Title - Sujet Fuel Storage Tank Removal Fuel Storage Tank Removal	
Solicitation No. - N° de l'invitation EP916-212422/A	Amendment No. - N° modif. 003
Client Reference No. - N° de référence du client 20212422	Date 2021-06-16
GETS Reference No. - N° de référence de SEAG PW-\$\$\$FG-374-80077	
File No. - N° de dossier fg374.EP916-212422	CCC No./N° CCC - FMS No./N° VME
Solicitation Closes - L'invitation prend fin at - à 02:00 PM Eastern Daylight Saving Time EDT on - le 2021-06-29 Heure Avancée de l'Est HAE	
F.O.B. - F.A.B. Plant-Usine: <input type="checkbox"/> Destination: <input type="checkbox"/> Other-Autre: <input type="checkbox"/>	
Address Enquiries to: - Adresser toutes questions à: Vani-Machado, Alba	Buyer Id - Id de l'acheteur fg374
Telephone No. - N° de téléphone (873) 355-4048 ()	FAX No. - N° de FAX () -
Destination - of Goods, Services, and Construction: Destination - des biens, services et construction:

Amendment 003 is issued for the following:

(1) Bidders' Question and Response;

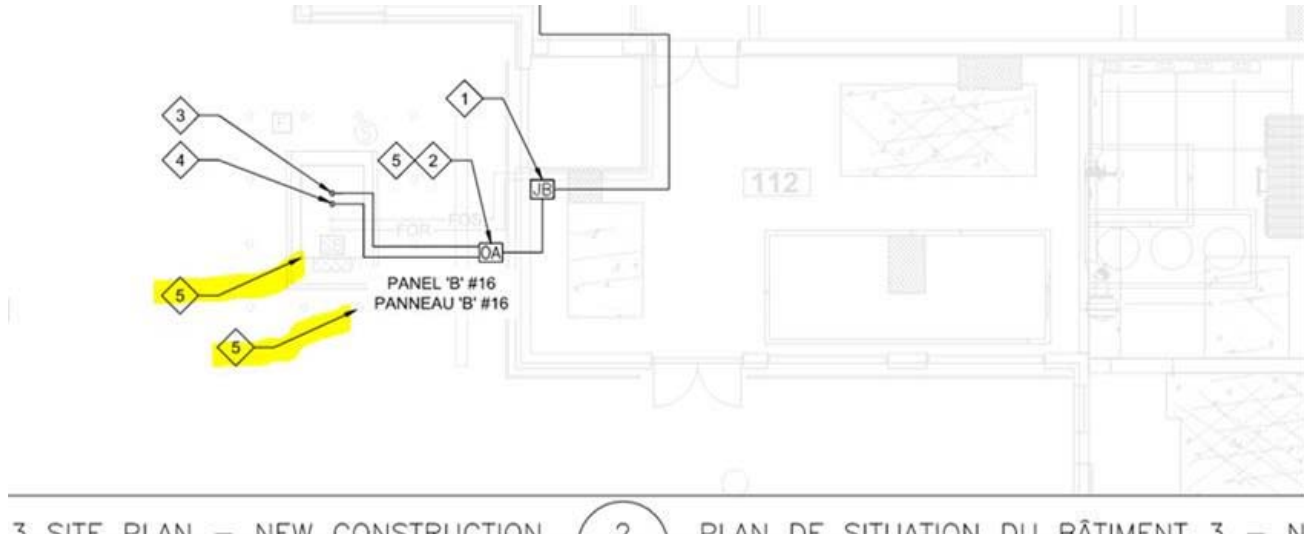
With reference to the Survey report on designated substance and hazardous building, some points are not perfectly clear.

Could you please confirm that all pipes to be dismantled are not insulated with asbestos?

Also could you please confirm that the existing wall penetration are to be reused? If not, does the wall where new penetration are to be created contain asbestos or any other designated substance?

ANSWER # 04: Please refer to the designated substance survey. The fuel piping does not have any insulation but may contain lead paint. The existing wall penetration is not to be reused. The new penetration area may contain asbestos and lead paint.
